HISTORIC AND DESIGN REVIEW COMMISSION

HDRC CASE NO: 2020-435
COMMON NAME: 1111 & 1115 N Palmetto
LEGAL DESCRIPTION: NCB 1302 BLK 3 LOT E 144.84 FT OF 10
ZONING: R-5, H
CITY COUNCIL DIST.: 2
DISTRICT: Dignowity Hill Historic District
APPLICANT: James Benfield/Benfield Real Estate
OWNER: James Benfield/Benfield Real Estate
TYPE OF WORK: Construction of two, 2-story residential structures
APPLICATION RECEIVED: September 28, 2020
60-DAY REVIEW: Not applicable due to City Council Emergency Orders
CASE MANAGER: Edward Hall

REQUEST:

SITE PLAN

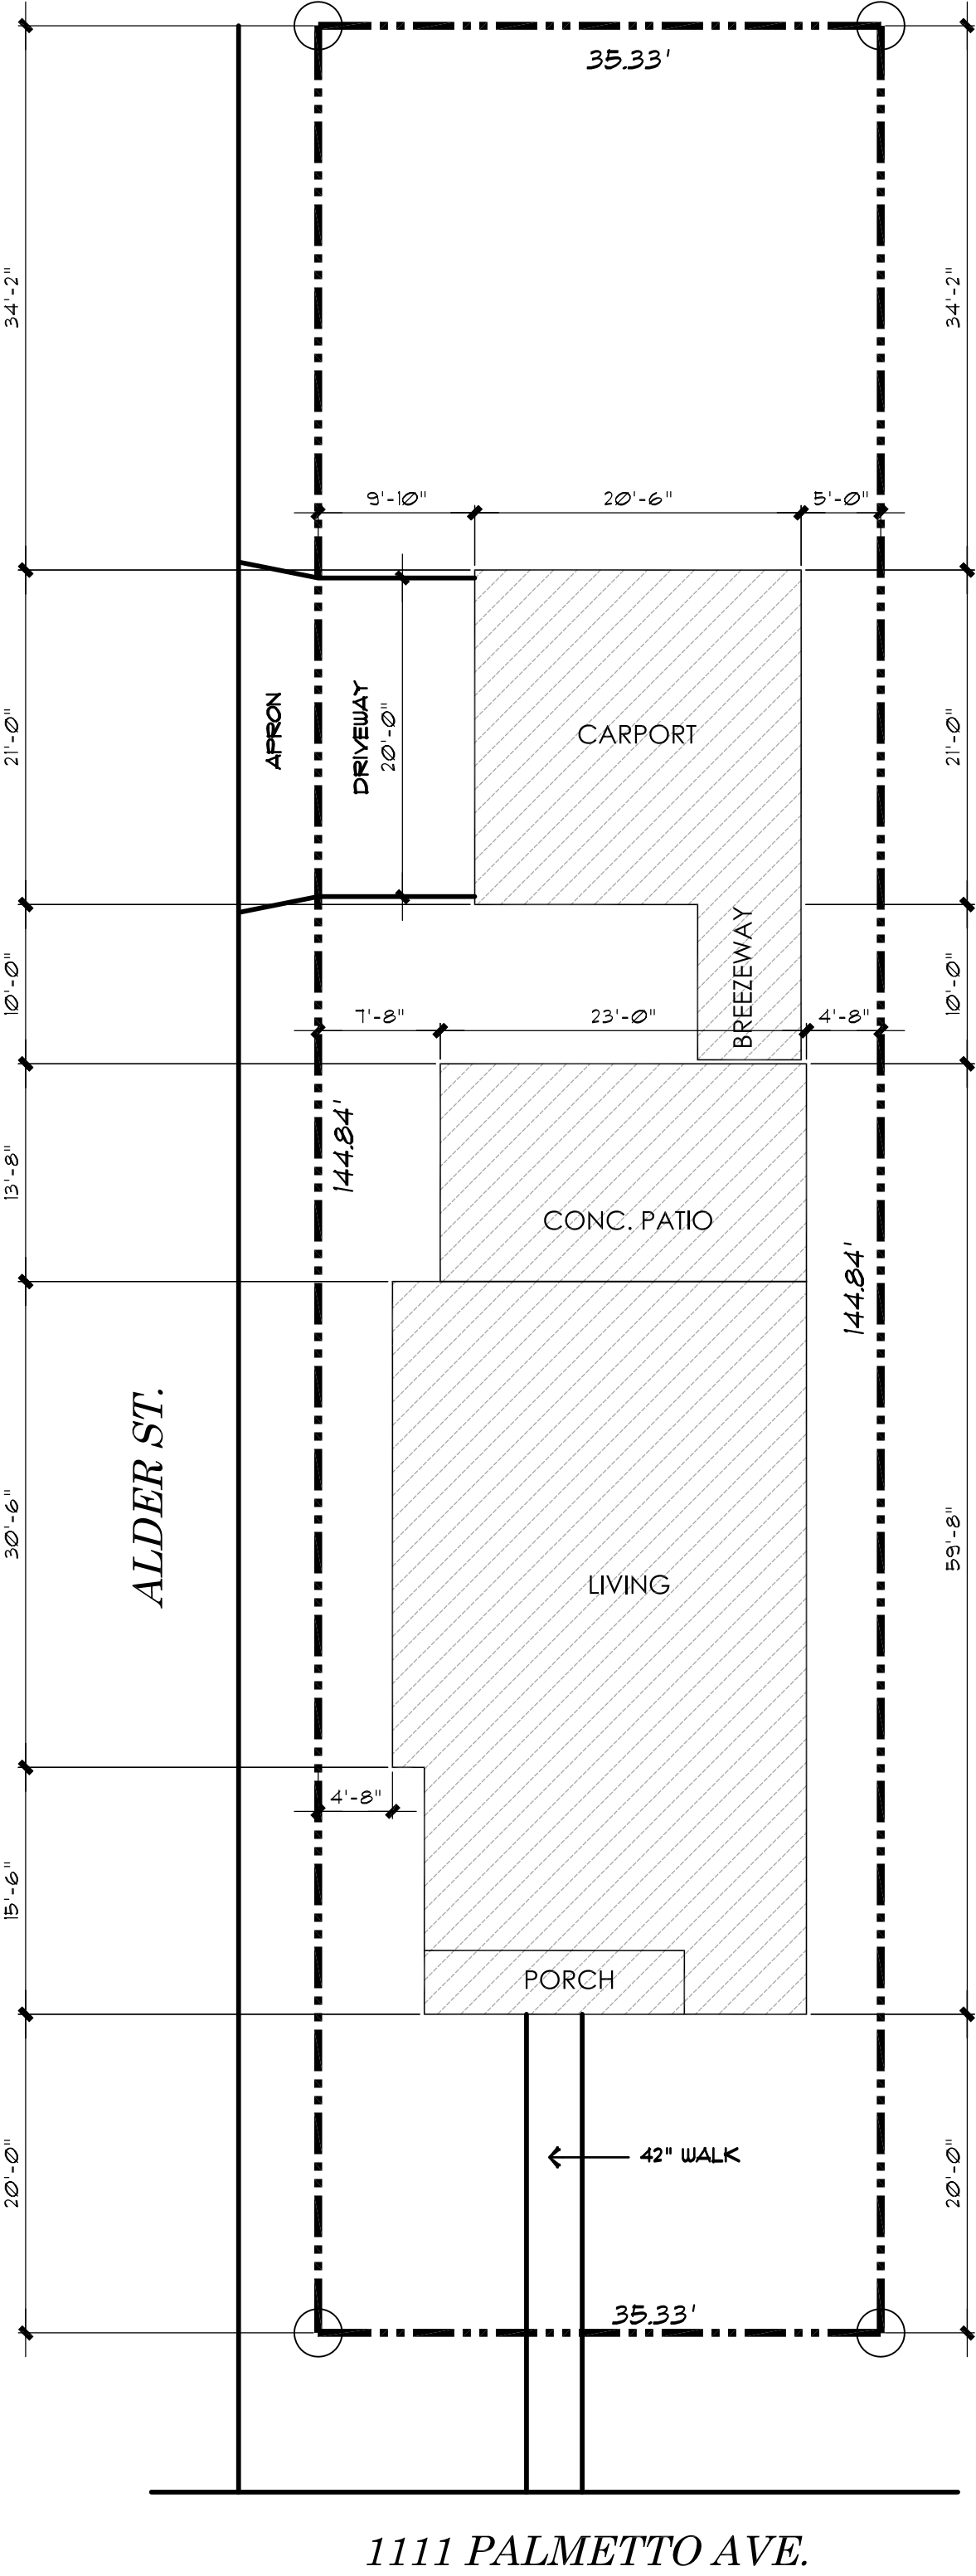
- 1a. **SETBACKS** – The applicant has proposed a setback of twenty (20) feet from the front property line. Additionally, the applicant has submitted a setback diagram noting a setback that is greater than all existing, historic setbacks on the block with the exception of one structure, the historic structure at the corner of N Palmetto and Sherman. Generally, staff finds that the proposed setback is appropriate and consistent with the Guidelines by responding to the setbacks of the most immediate historic structures.

- 1h. LOT COVERAGE – Per the submitted site plan, the proposed lot coverage is consistent with the Guidelines.
- 1i. MATERIALS – The applicant has proposed materials that include composite siding, asphalt shingle roofs, wood columns and wood trim. The proposed siding should feature an exposure of four inches, a smooth finish, a thickness of ¾” and mitered corners. Columns should be six inches square and feature both capital and base trim as well as chamfered corners. The applicant is responsible for submitted a column detail to staff.

- 1n. SITE ELEMENTS (Driveways) – The applicant has proposed to access the rear carport with a driveway of twenty-one (21) feet in width. This is inconsistent with the Guidelines. Staff finds that the proposed driveway should be separated in width to be consistent with the Guidelines.

- 1o. WALKWAY – The applicant has proposed a concrete walkway to connect the front porch to the right of way. The applicant has proposed a width of forty-two (42) inches. This is consistent with the Guidelines.

- vi. That the proposed driveways be separated in width to be consistent with the Guidelines as noted in findings 1n and 2n.
- vii. That a detailed landscaping plan be submitted for review and approval as noted in findings 1p and 2p.
